Aqueous Solutions (owner) AQS-MFG-GLASS_DIGEST-IN01
GLASS_DIGEST fabrication drawing IN01 (AQS-PLAN-006 M3; grap
Type: fabrication drawing (GA / nozzle orientation / part sheet) Rev dbddeeb2 Issued
Created: flow graph pipeline Approved: not approved (study)
Sheet 1 of 1 AQS-DWG-001

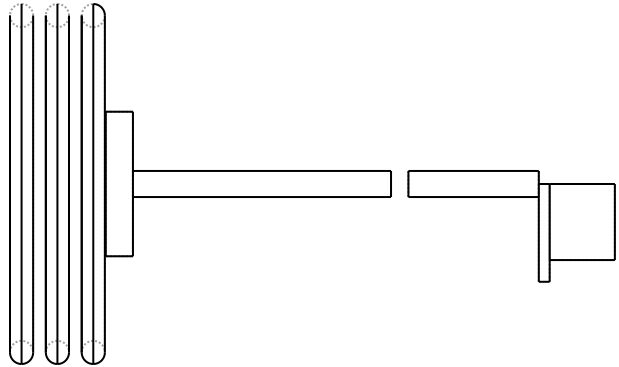
Graph revision AD - in01: Agitator: shaft D24 with 4-blade 45 deg PBT D133 (PVDF per design.material) at 358 rpm; 0.09 kW gearmotor shown as its purchase
Graph revision AD - in01: Q3 coil: PVDF DN15, 3 tube rings R 155 at 33 mm pitch per the design heat row (graph HL-Q3-A/B-HX6); the schedule N1/N2 service
Graph revision AD - in01: The node internals row is none: the tracker records no internal solid; the agitator and coi
